Todmorden Mills Wildflower Preserve

February 22, 2021

To: Toronto and East York Community Council

Re: Comments on the Report for Action Item TE 23.55 for consideration on February 24, 2021; 954, 956,958 Broadview Avenue and 72 Chester Hill road, OPA and ZBA Submission.

Appendix E Hydrogeological Report for DK application This shows the depth of the construction for underground parking level 3 intercepting the groundwater (blue line)

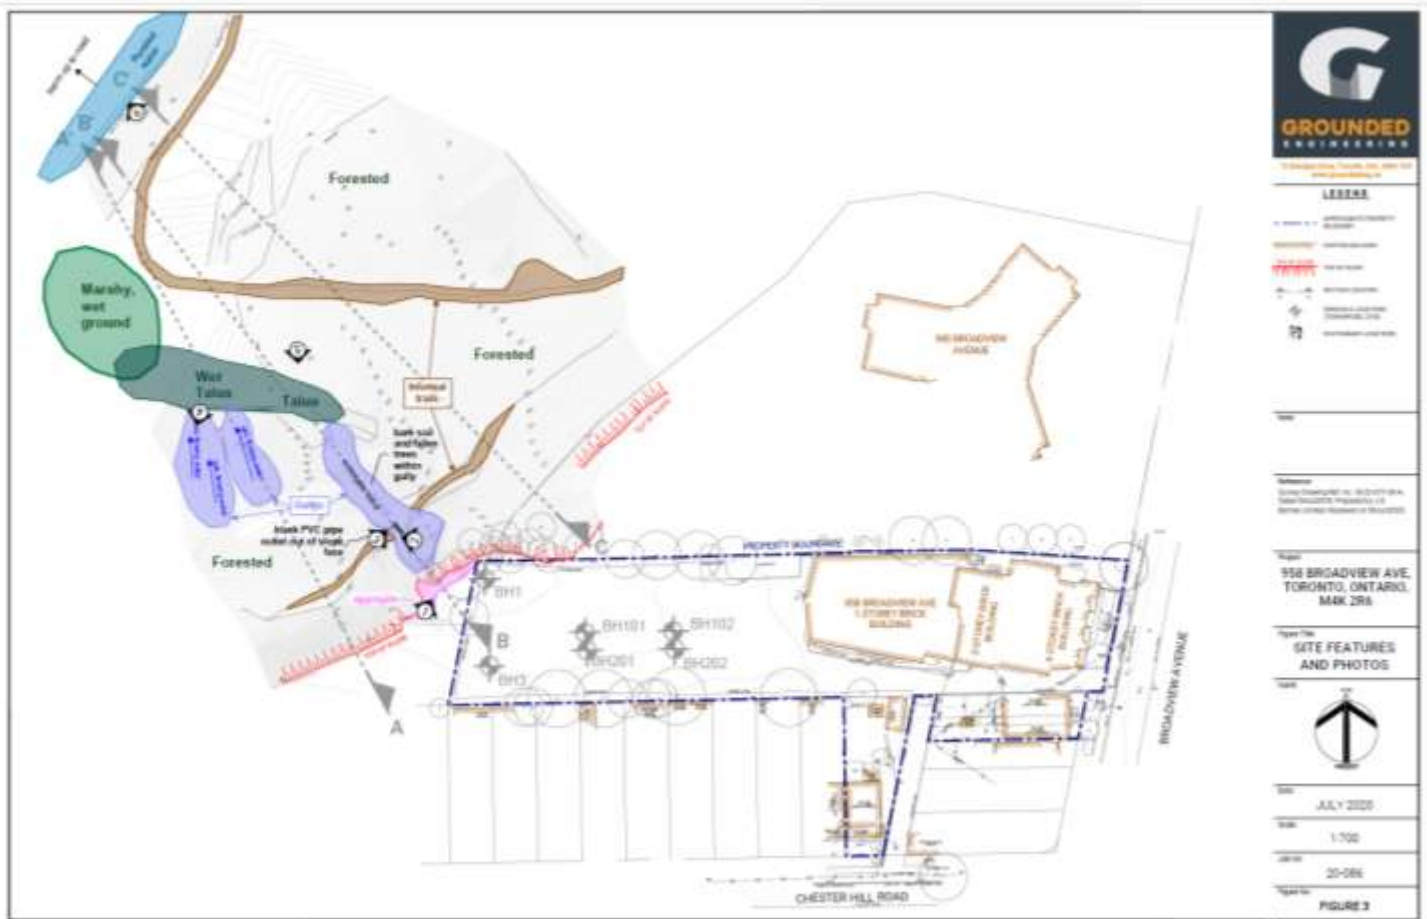
page 12 TMWP comment: There are several running water features on the site. We object to this conclusion as the third level of parking will intercept the perched groundwater. As this water is proposed to be directed to a sewer, the water seepage from the slope area will be lost, impacting the ecological integrity of the wetland areas of the site, including a recently restored wetland. The zone of influence was too limited in scope to capture the impacts on the wetlands.

13. PLAN SKETCH OF SLOPE

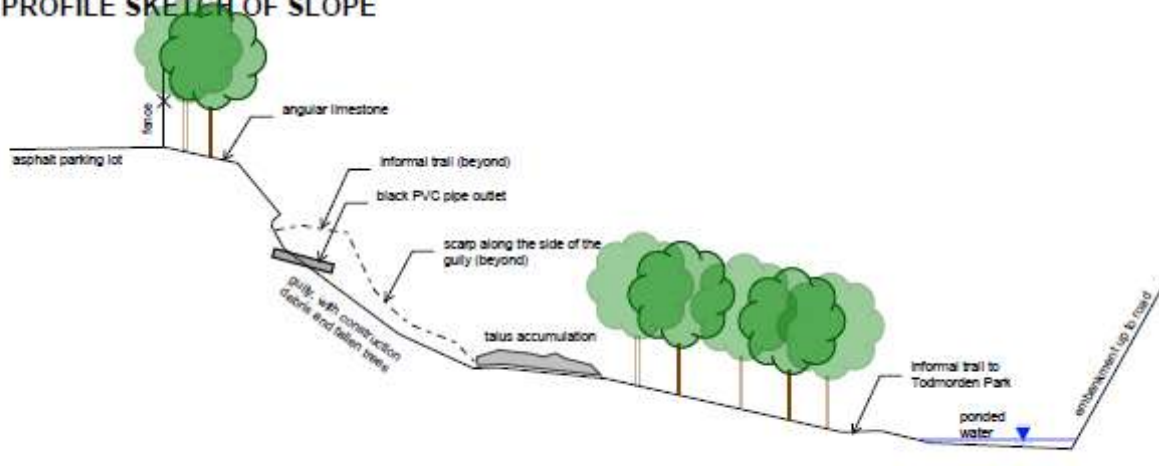
page 4 slope inspection form (Slope and Stability Report) Note reference to wet ground and flowing water

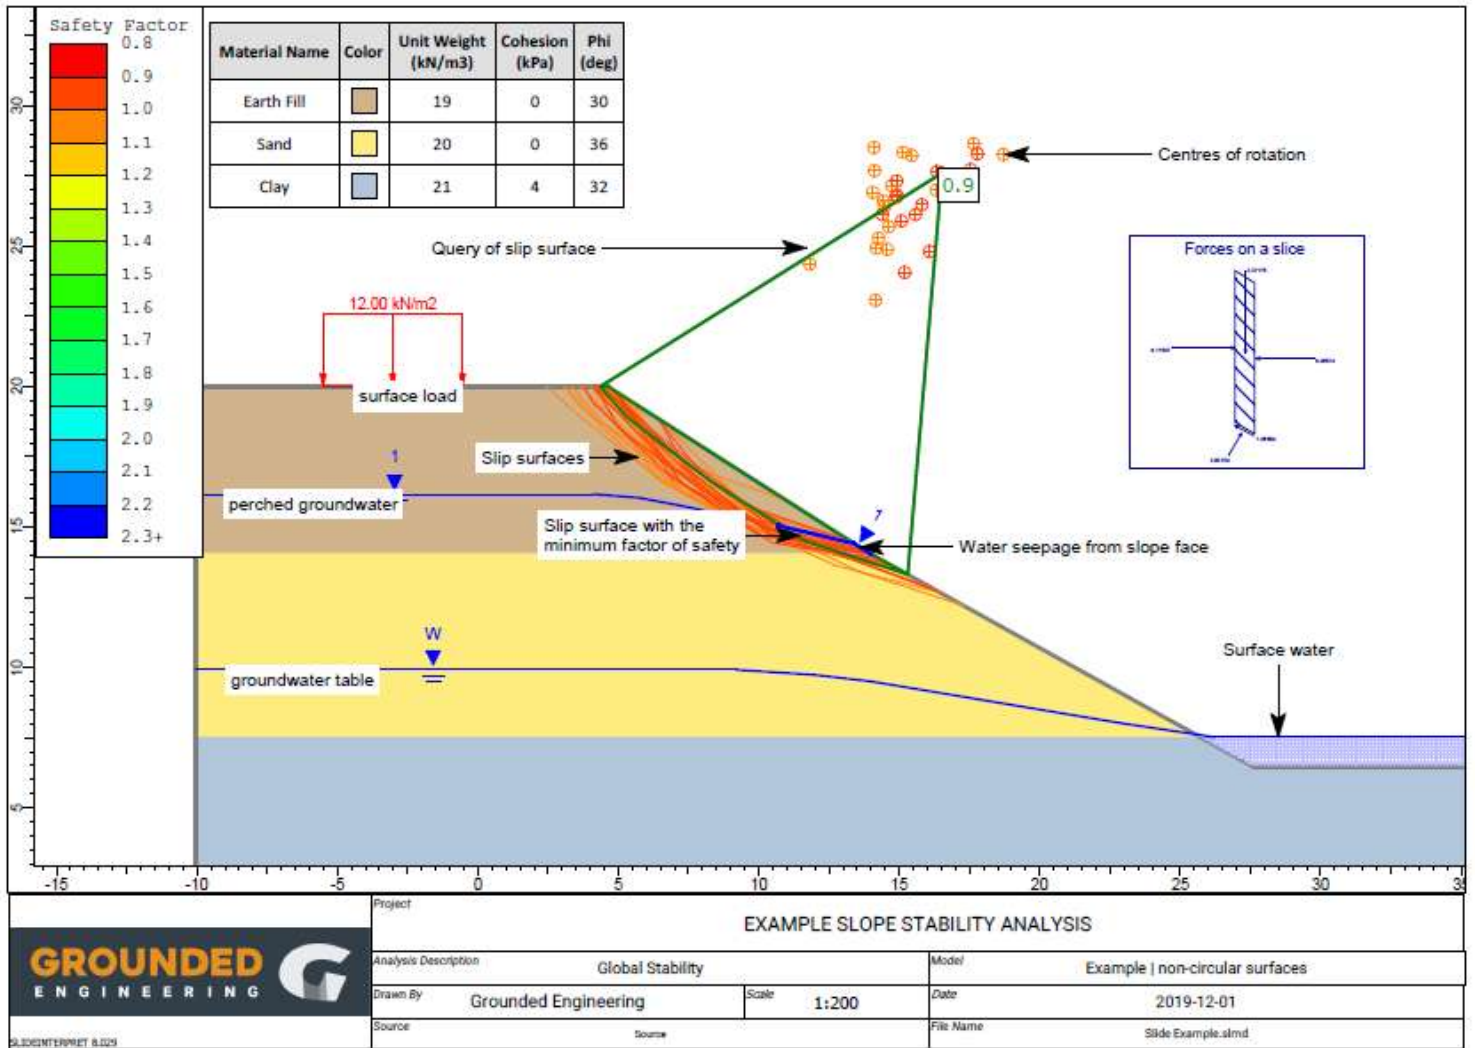
Note wetland plants and seepage supporting them which runs year round and supports fauna as well as plants.

Note perched groundwater which seeps from the slope face and runs down to the wetland area supporting the ecological functions of the area.
